ADDENDUM NUMBER ONE (1) 15 SEPTEMBER 2014

JORDAN'S SWEET SHOPPE

FROM: PREVOT DESIGN SERVICES, APAC

#### PROJECT NO. A0314

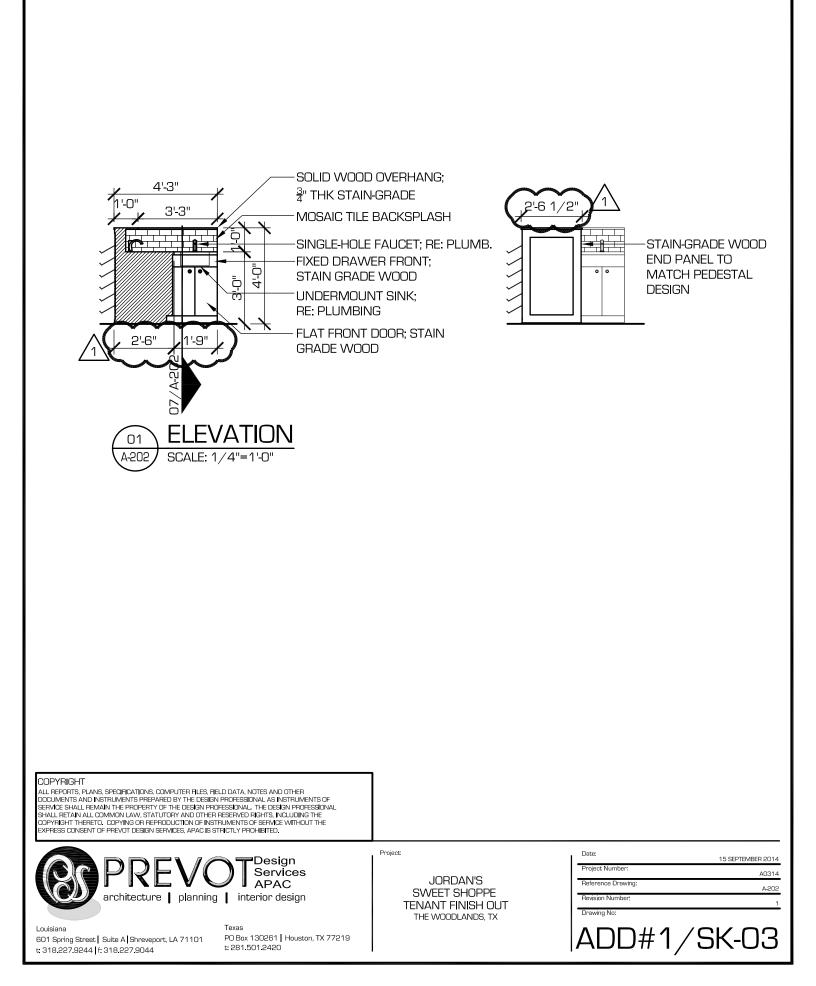
- b. Detail 01/A-101: See SK-01 for revisions to sink location from Workroom to Cash wrap, and addition of furred out plumbing wall at demising wall of shell building. New Partition Type D1. See SK-02

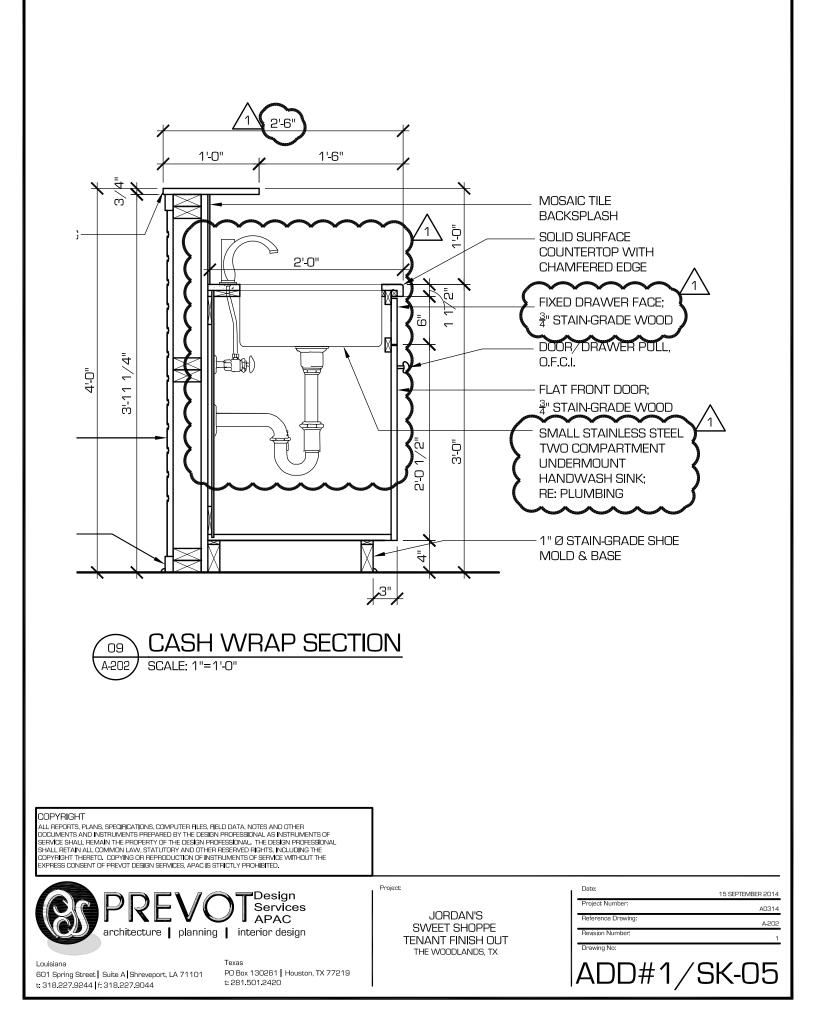
- 2. SHEET A-202 INTERIOR ELEVATIONS & MILLWORK DETAILS:
  - a. For revisions to Cash Wrap & Workroom interior elevations and millwork, see Sk-O3 thru SK-O5.

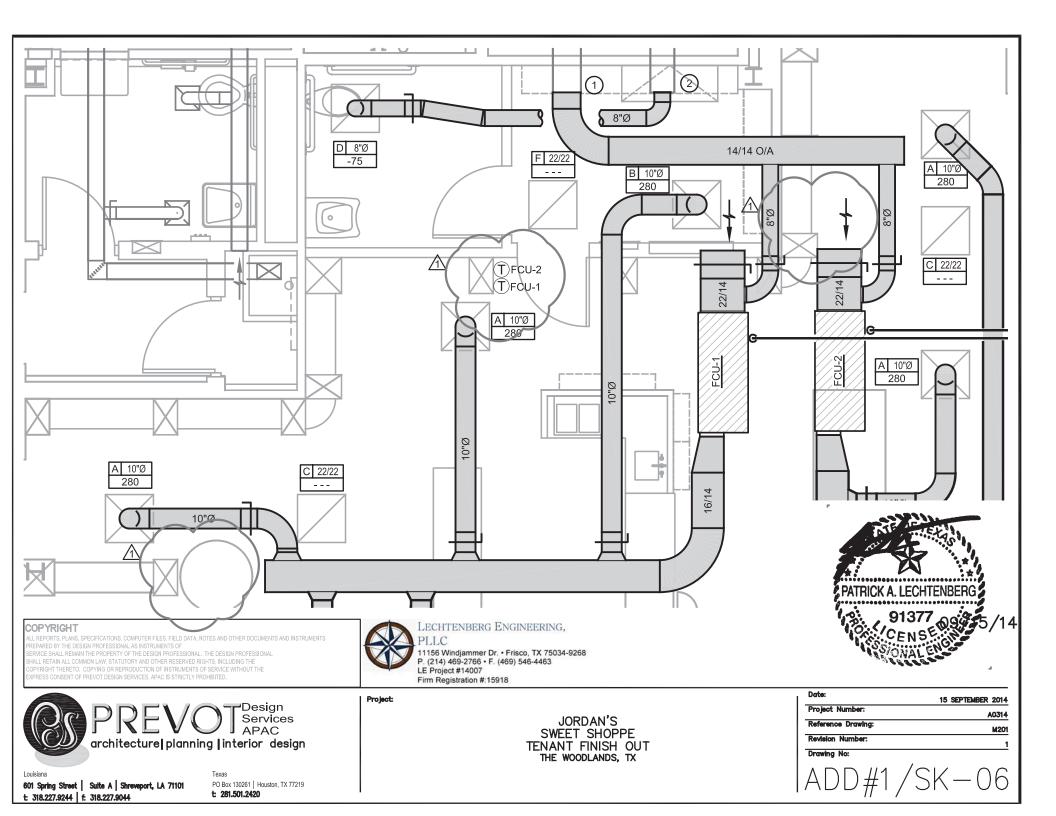
- 3. SHEET M-201 MECHANICAL FLOOR PLAN:
  - a. See Sk-06 for revisions to thermostat locations.
- 4. SHEET E-201 ELECTRICAL FLOOR PLAN:
  - a. See Sk-07 for revisions to outlet location from demising wall of shell building spaces.

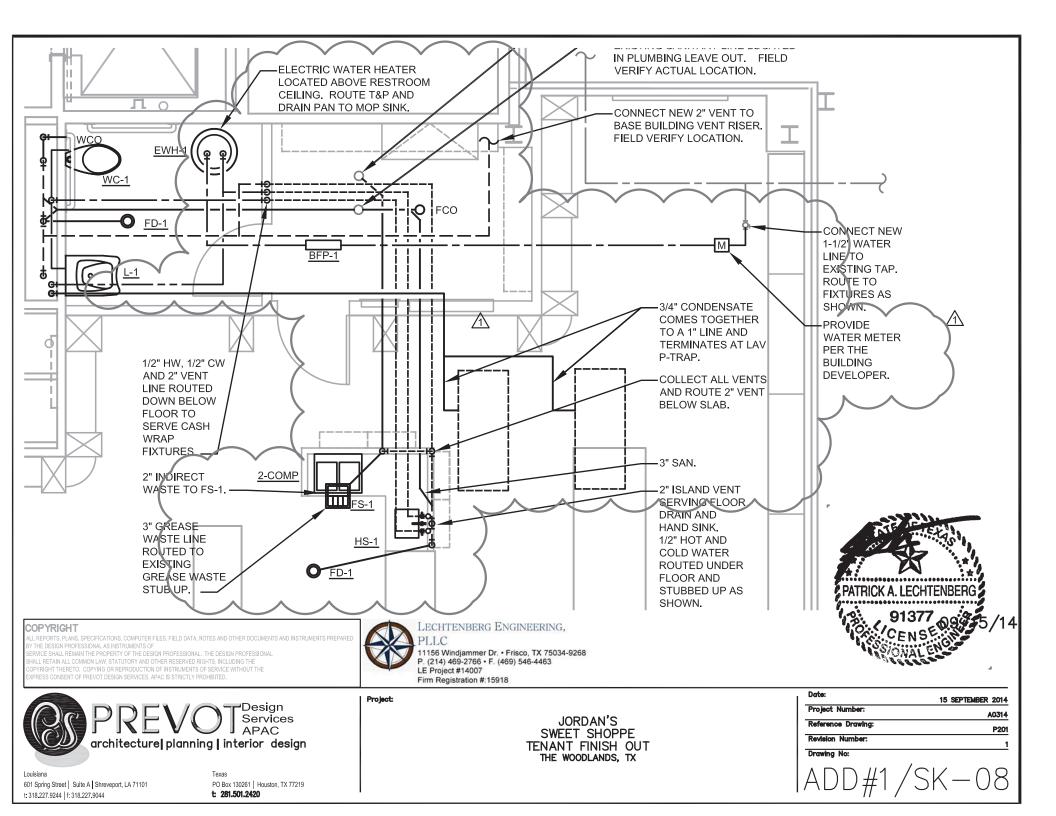
- 5. SHEET P-201 PLUMBING FLOOR PLAN:
  - a. See Sk-08 for revisions to sink location from Workroom to Cash Wrap.
- 6. SHEET P-901 PLUMBING DETAILS & SCHEDULES:

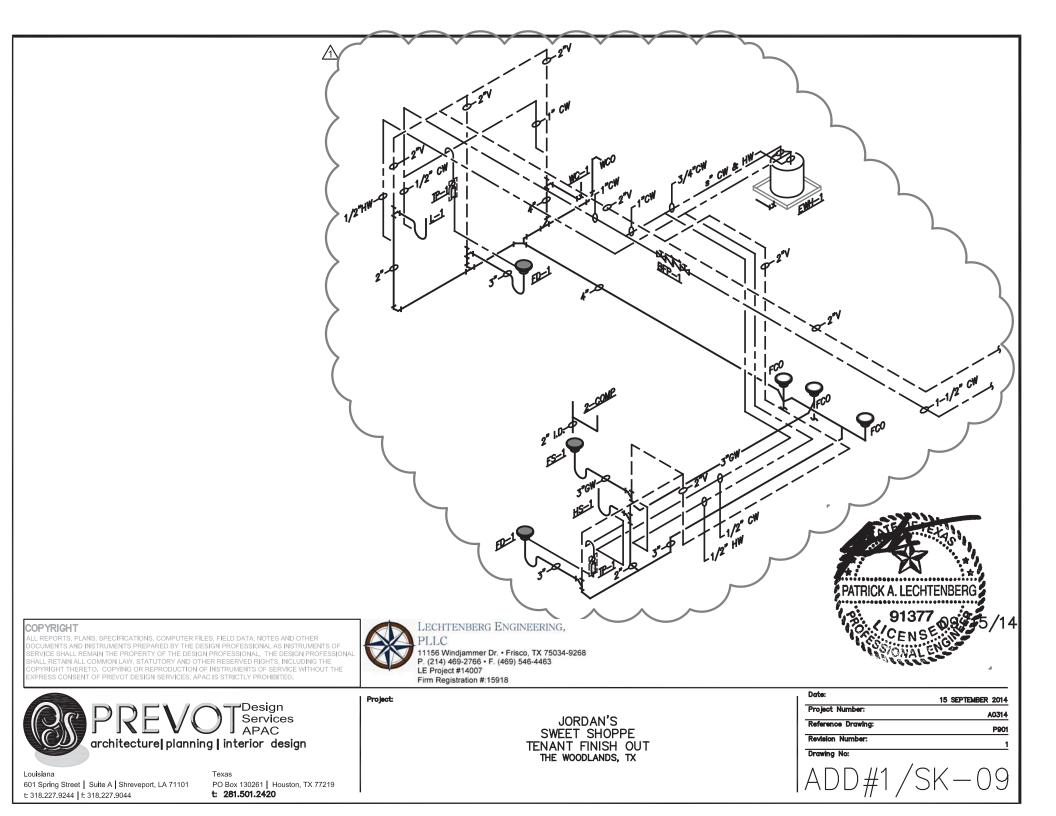
- a. See Sk-09 for revisions to plumbing riser.
  - b. See SK-10 for revisions to PLUMBING FIXTURES and PLUMBING FIXTURE CONNECTION SCHEDULE.
